**Re: Initial Submission Review – Green Valley Ranch East Site Plan No. 15 - Site Plan and Plat**  
Application Number: **DA-1662-26**  
Case Number(s): 2022-4014-00; 2022-3019-00

On behalf of Oakwood Homes, Aztec Consultants, Dewberry Engineering and Terracina Design, we have reviewed the comments dated March 24, 2022. The following is a response to comments.

SHEET 3 OF 36

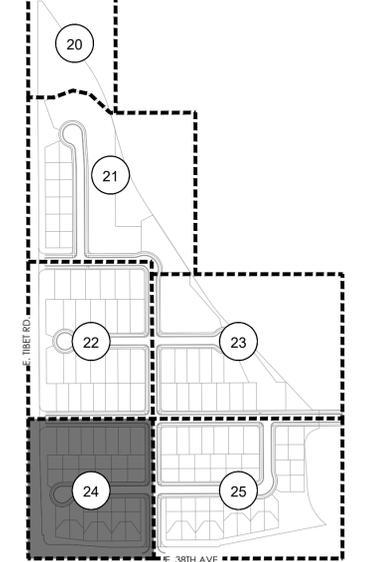
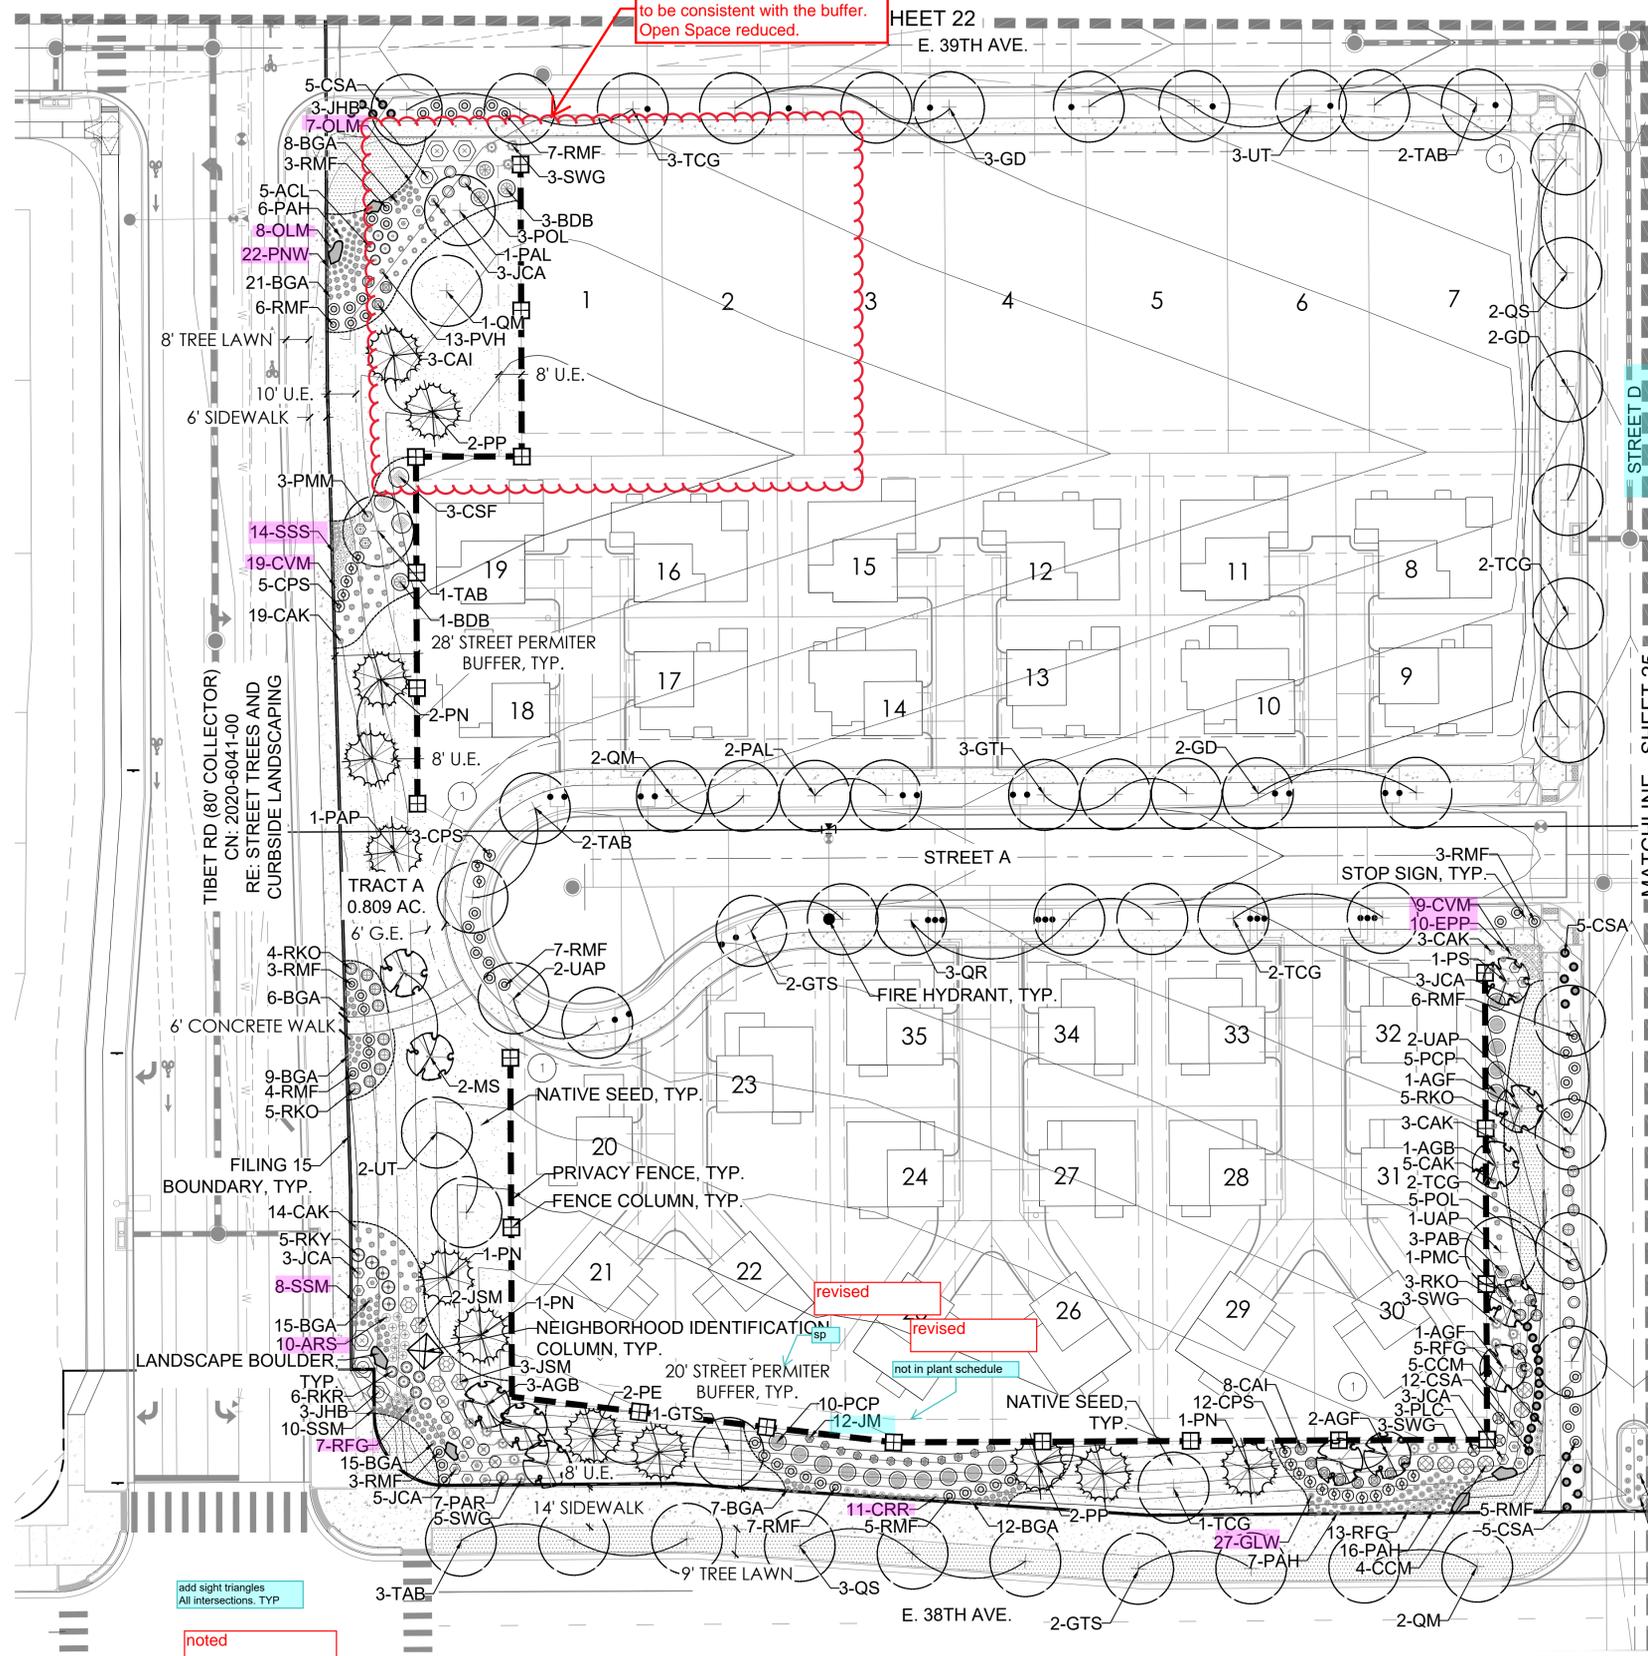
add sight triangles All intersections. TYP  
noted

Lots widened and buffer reduced to be consistent with the buffer. Open Space reduced.

street names revised

SHEET 25 OF 36

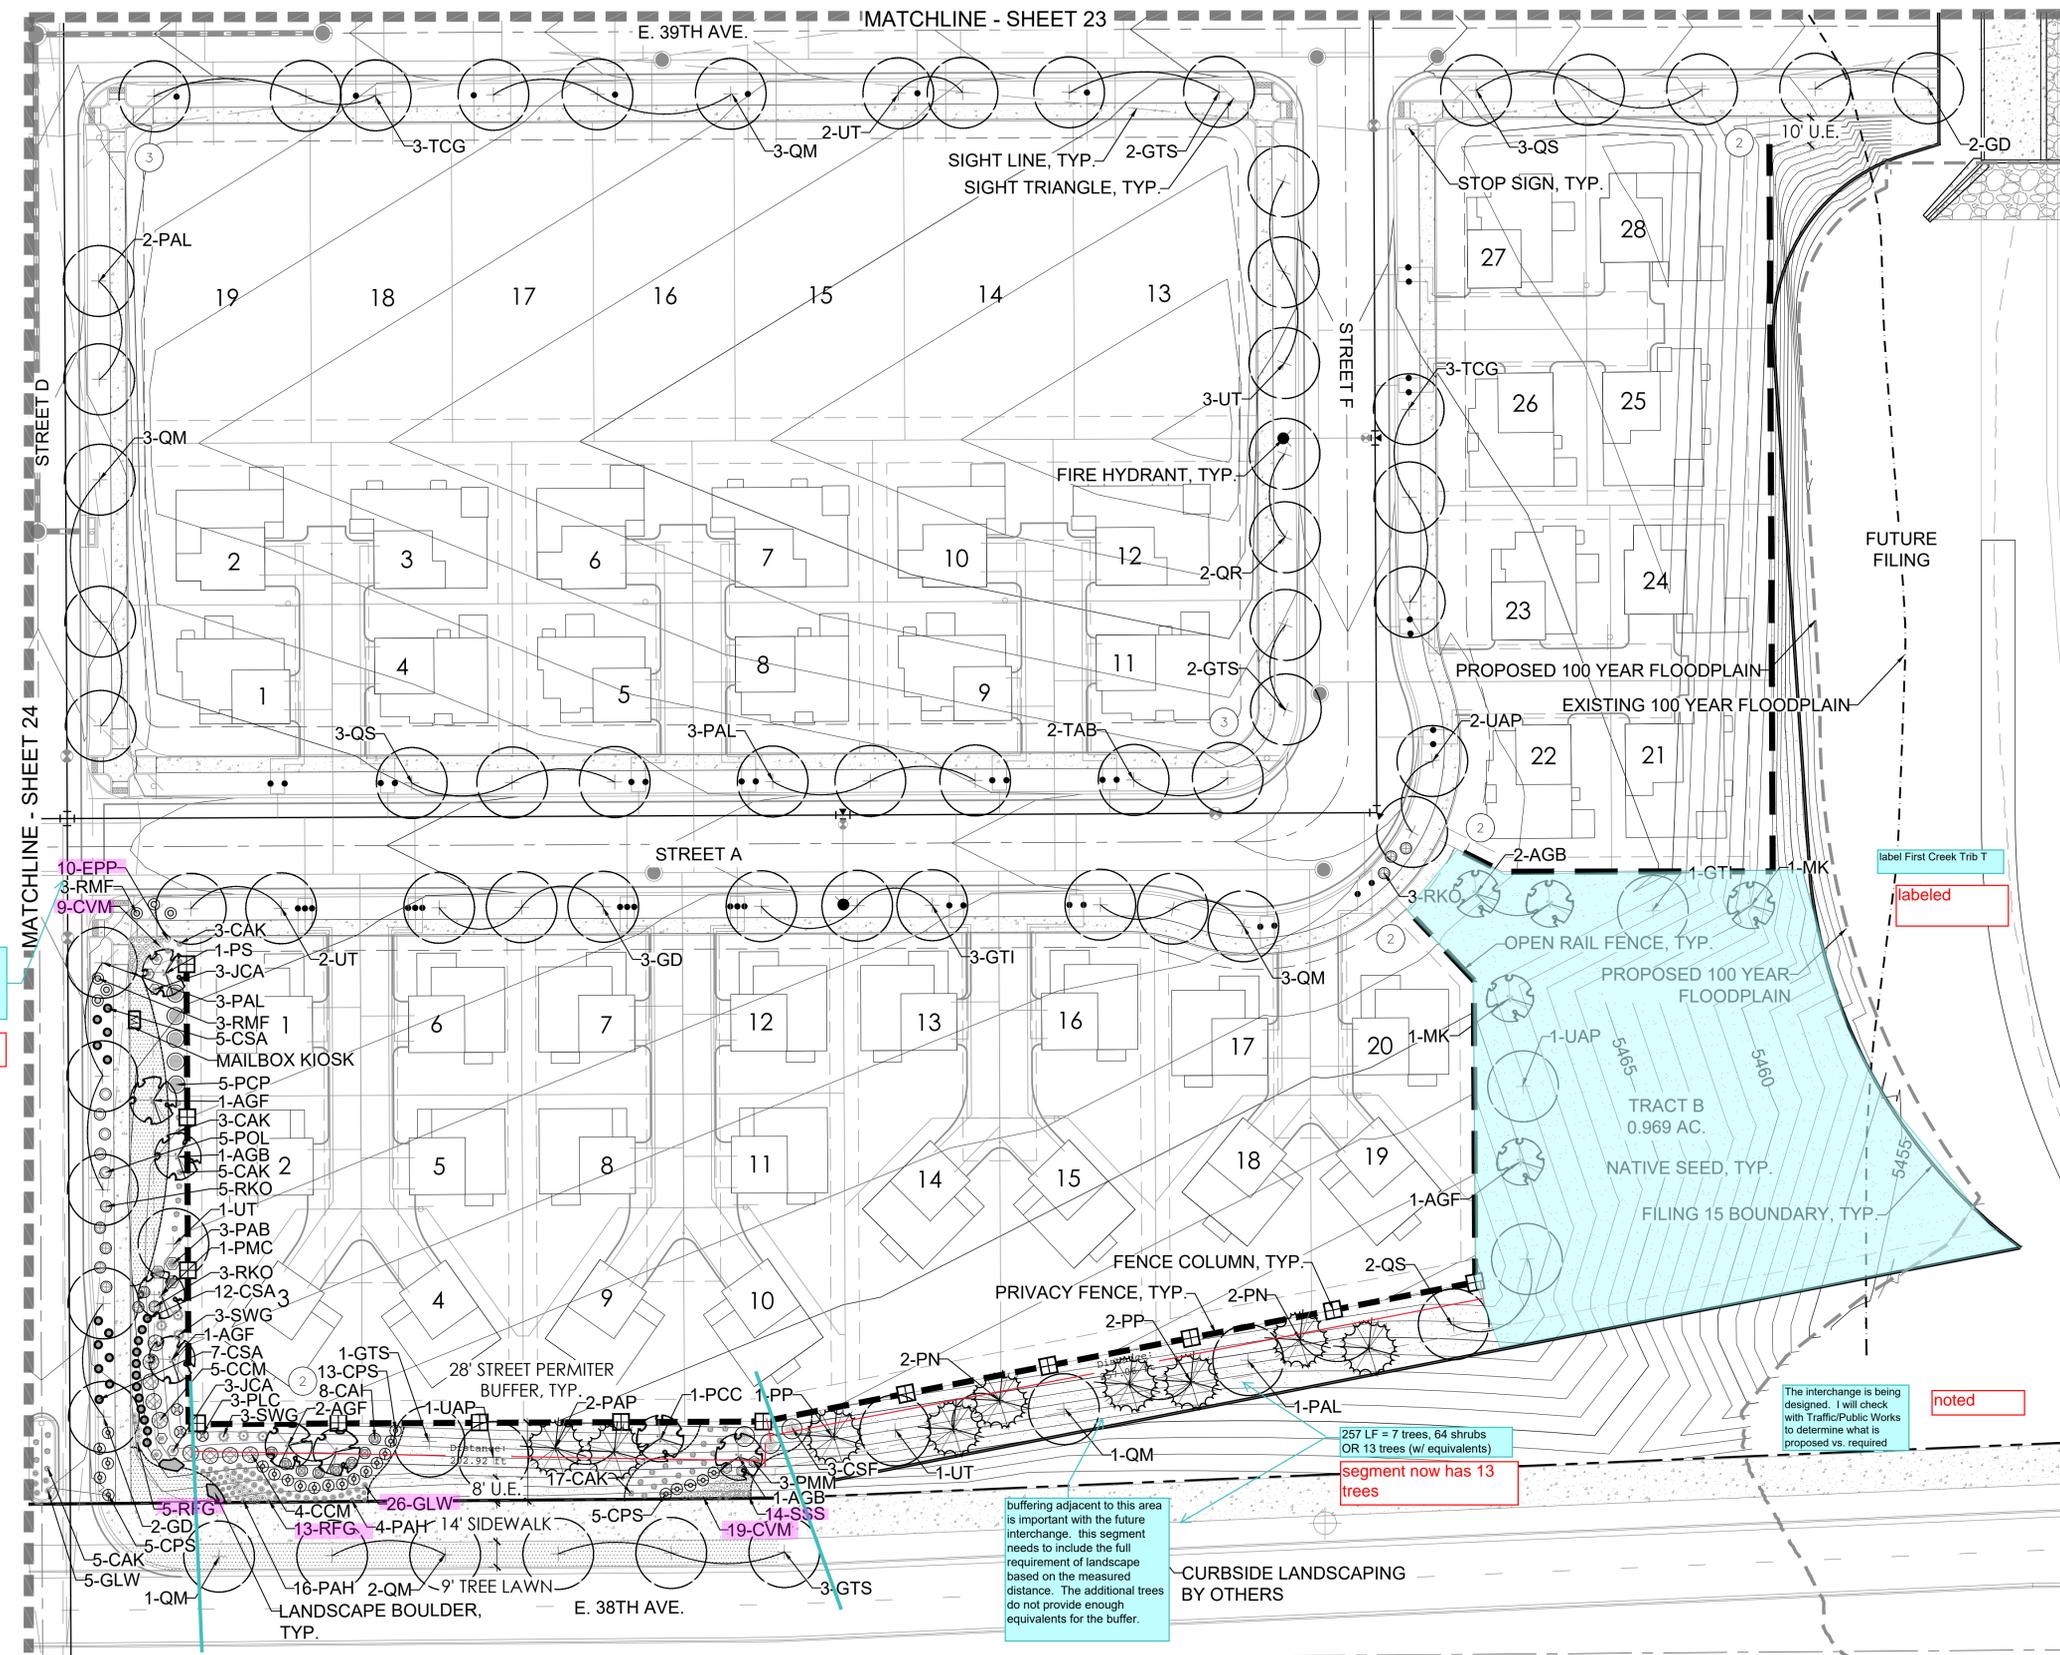
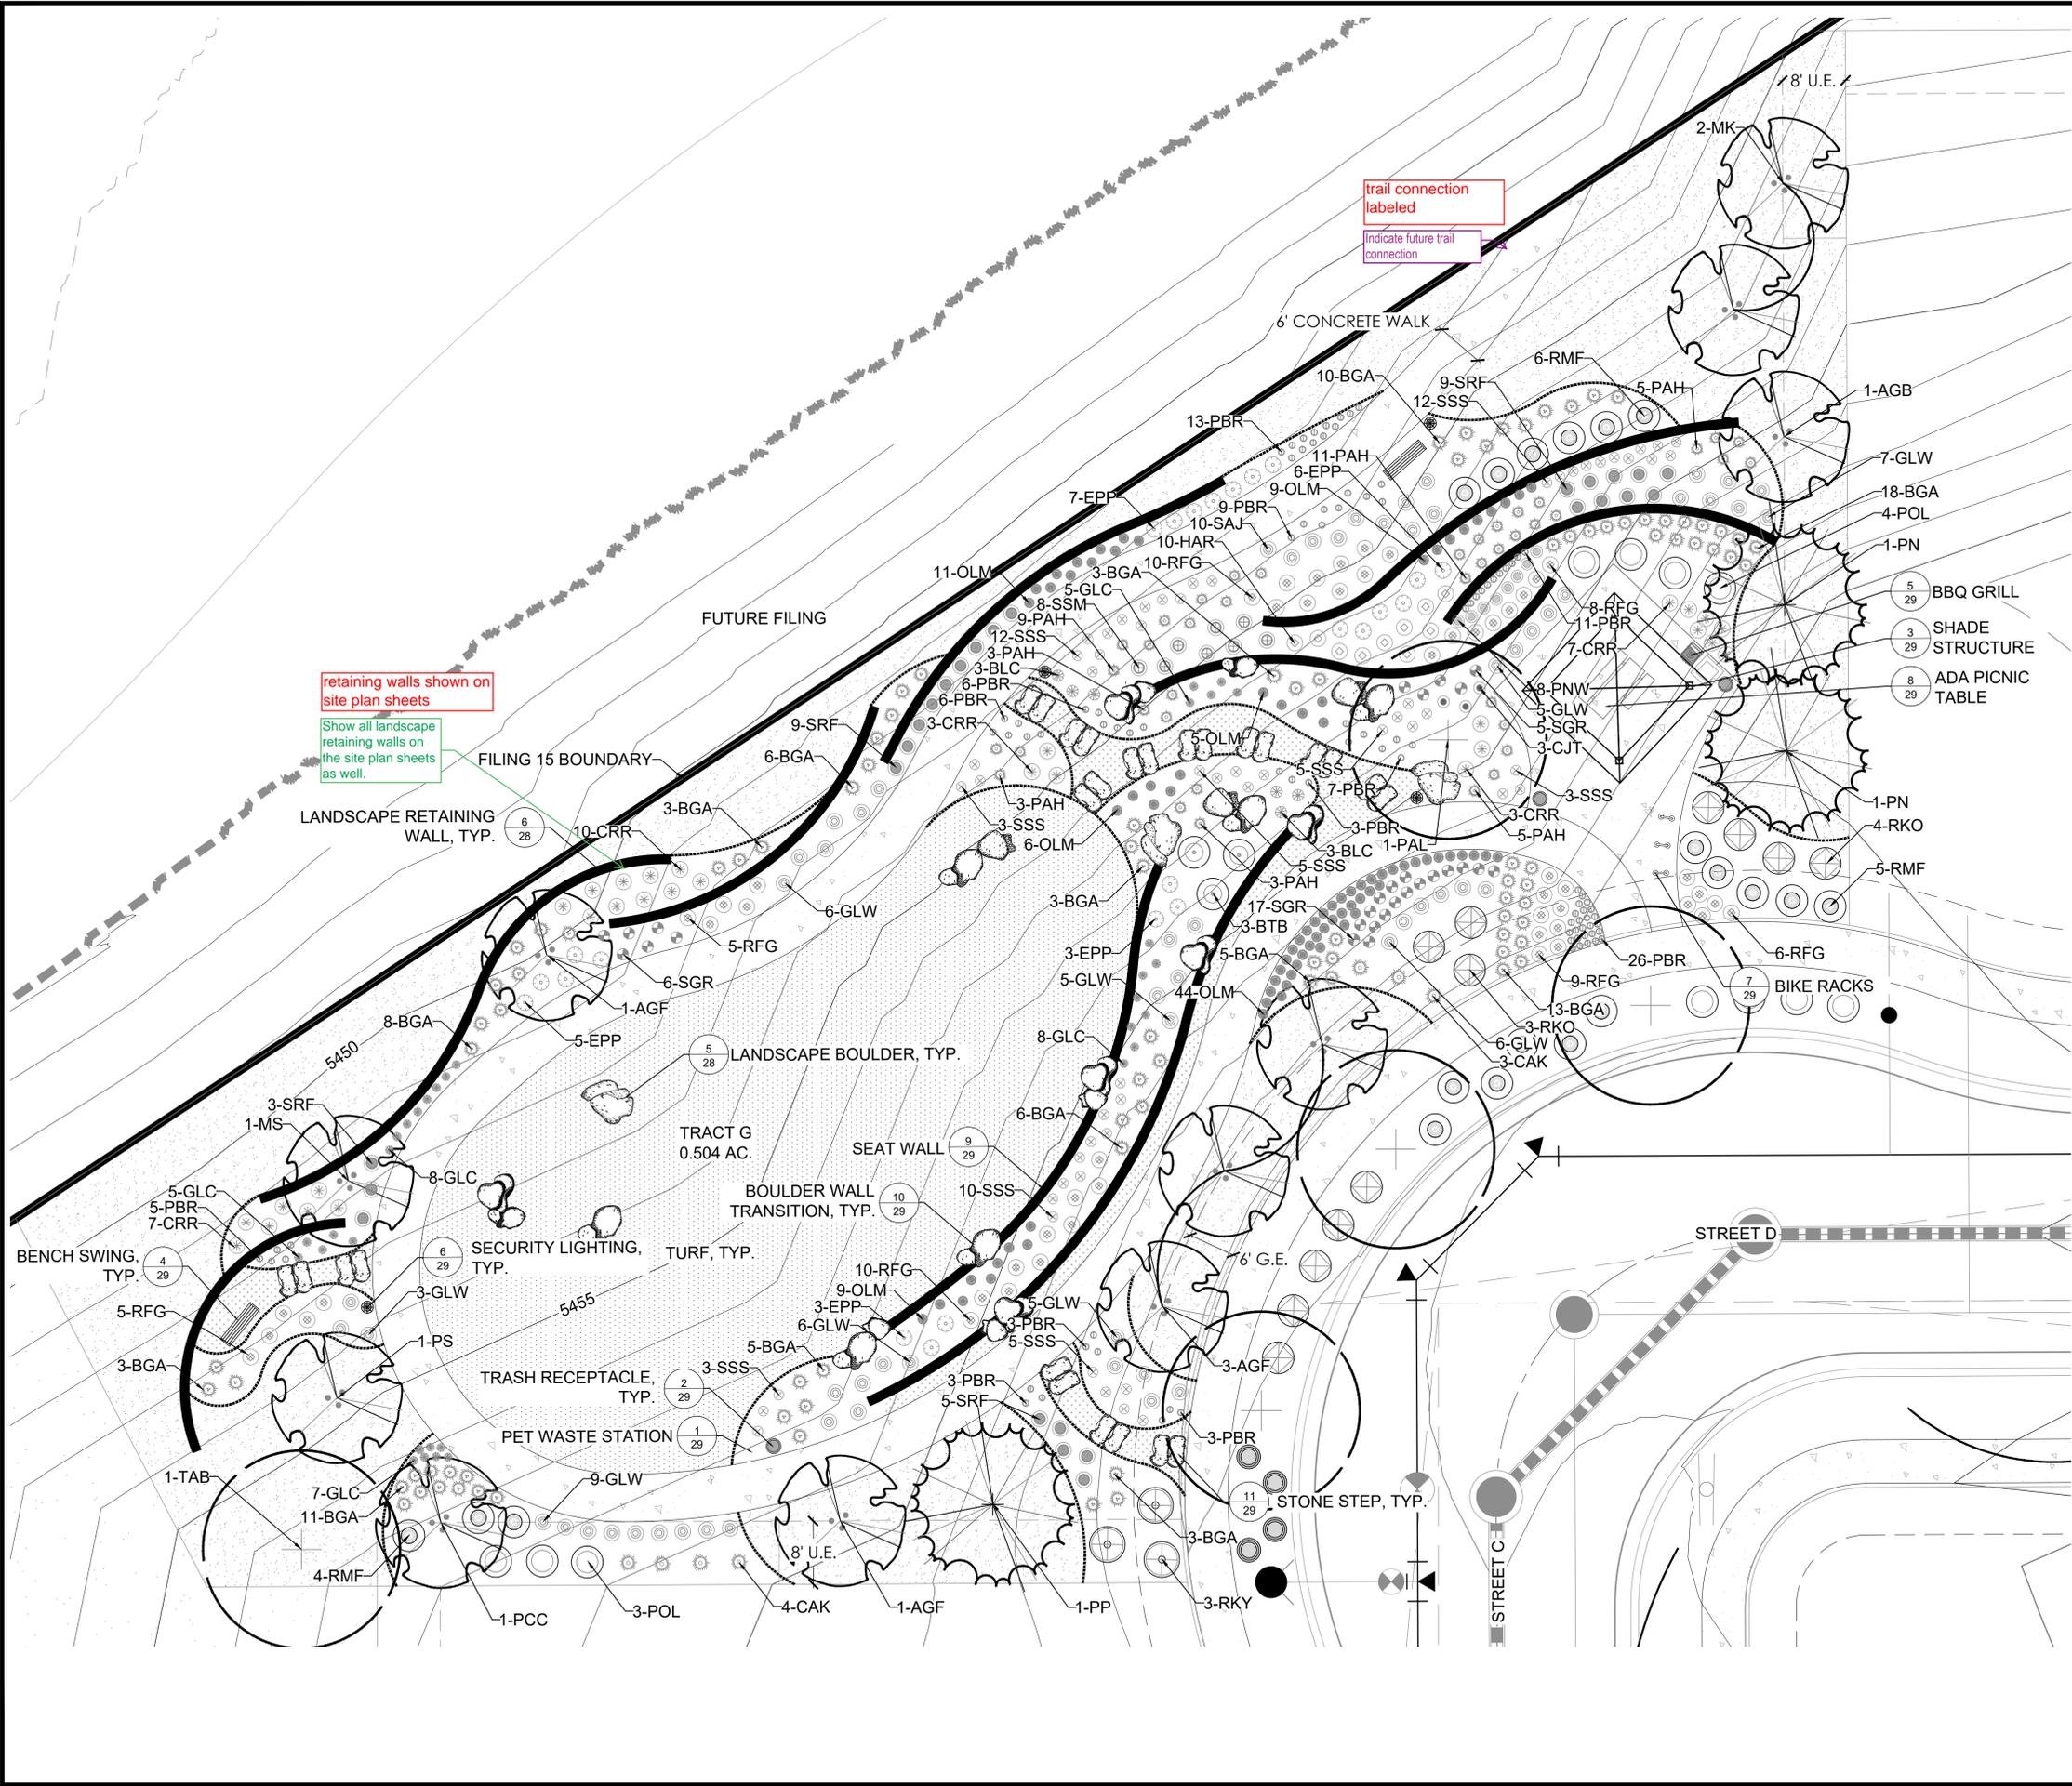
Perennials are permitted but cannot be included in the buffer landscape plant count  
**noted**

label First Creek Trib T  
**labeled**

The interchange is being designed. I will check with Traffic/Public Works to determine what is proposed vs. required  
**noted**

buffering adjacent to this area is important with the future interchange. this segment needs to include the full requirement of landscape based on the measured distance. The additional trees do not provide enough equivalents for the buffer.

257 LF = 7 trees, 64 shrubs OR 13 trees (w/ equivalents)  
**segment now has 13 trees**

**5 LANDSCAPE BOULDER**  
SCALE: NTS

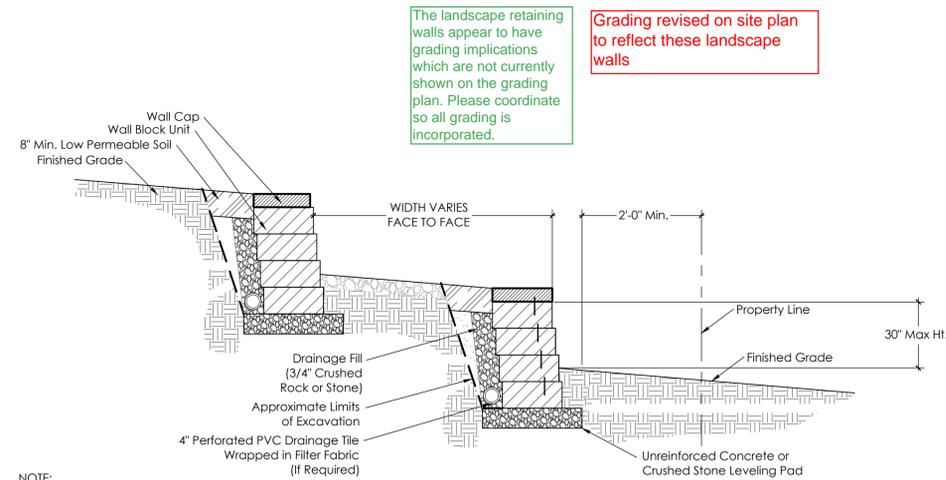
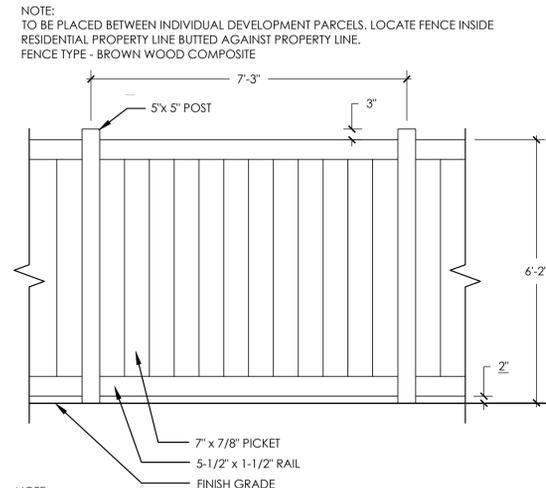
The landscape retaining walls appear to have grading implications which are not currently shown on the grading plan. Please coordinate so all grading is incorporated.

Grading revised on site plan to reflect these landscape walls
